135 BROADWAY RESIDENTIAL TOWER

Cambridge, Massachusetts

Design Review Submission
Issued January 28, 2022
Revised March 15, 2022

INSET AMENITY BALCONY AT THE NORTH FACADE LEVEL 6

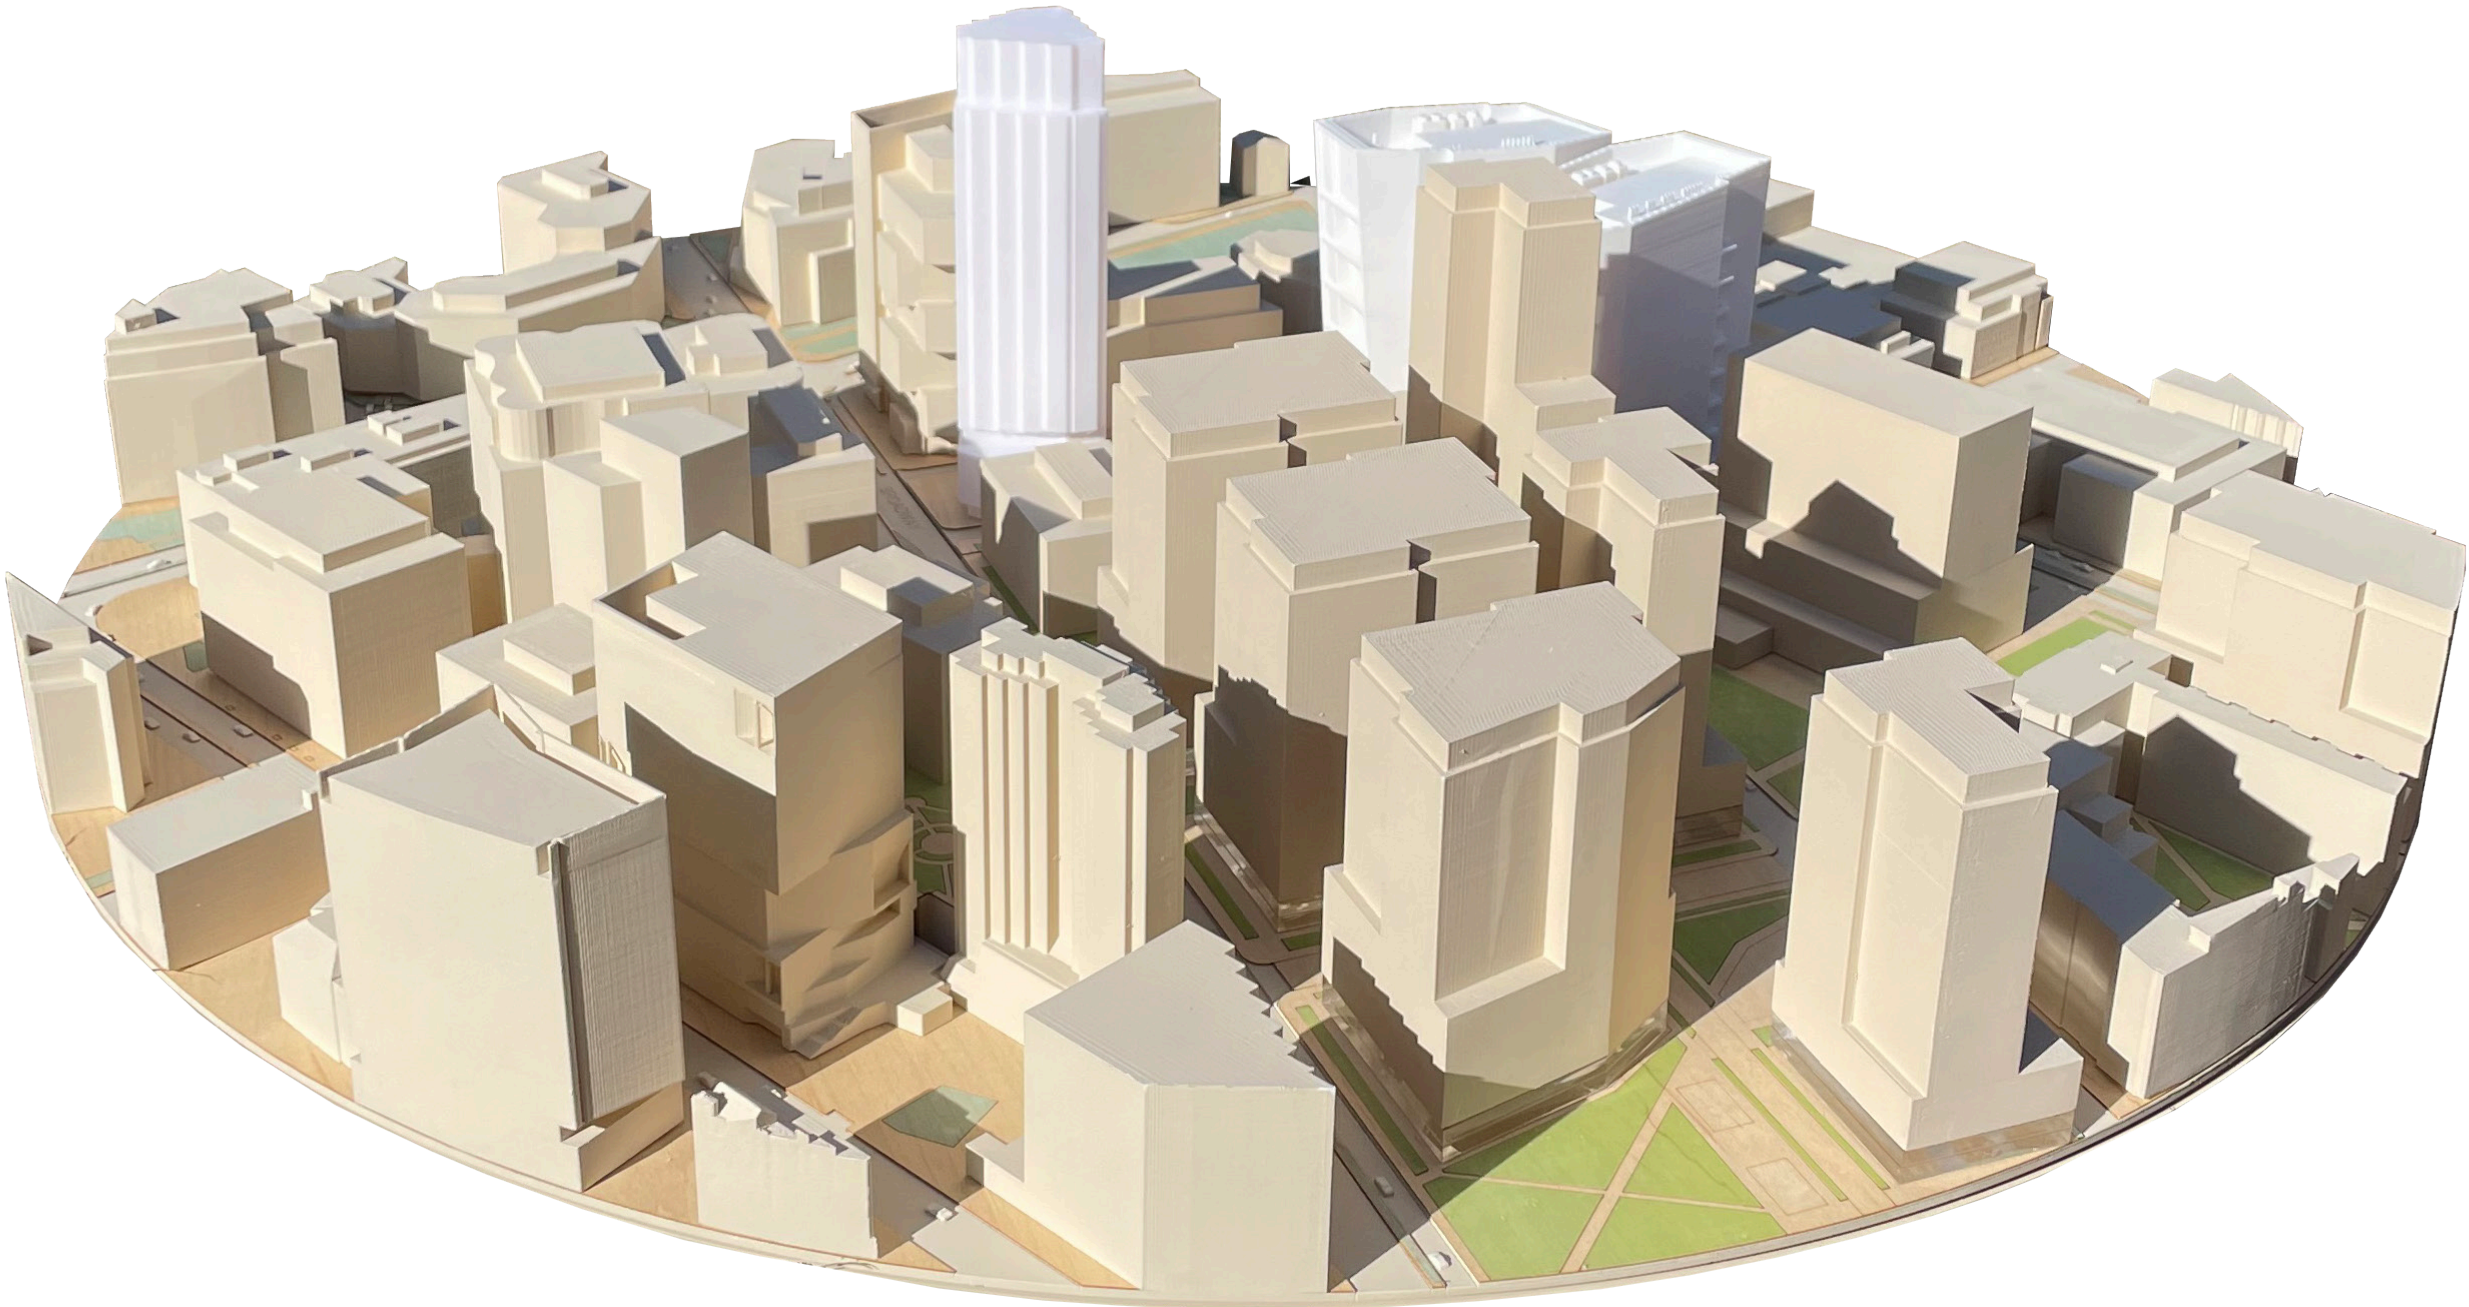
Comment:
Consider stepback on the north side – facing the plaza – recommended by K2 guidelines for buildings facing parks.

Response:
The building footprint is required to be able to meet the Gross Floor Area minimum requirement. Stepping back the north side will reduce square footage, or force the building southward, blocking the views to Akamai entrance. The revised design submission adds an inset amenity balcony at the North Façade Level 6, which helps to further define the podium base.
